Access Compliance Report

Public Rights-of-Way

(Pedestrian Signals)

Intersection ID: N/A	Main Street:	Cross Street: N/A	Location: N/A
ADA ID: D1229BA3FB5B	Signal Type: One Push Button-APS	Overall Compliance: No	Severity Score: BTN 1: N/A BTN 2: N/A No BTN: N/A
Codes/Mitigation Info/Possible Solution		Field Measurements/Component Compliance

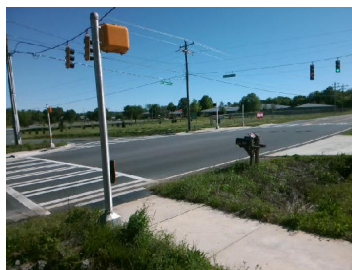
PROW/ADA: R404.2, R406.2, R209.1, MUTCD 4e.10

Possible Solutions: Remove & Replace
Replace APS Button With New APS Button.
Remove and Replace Clear Space.
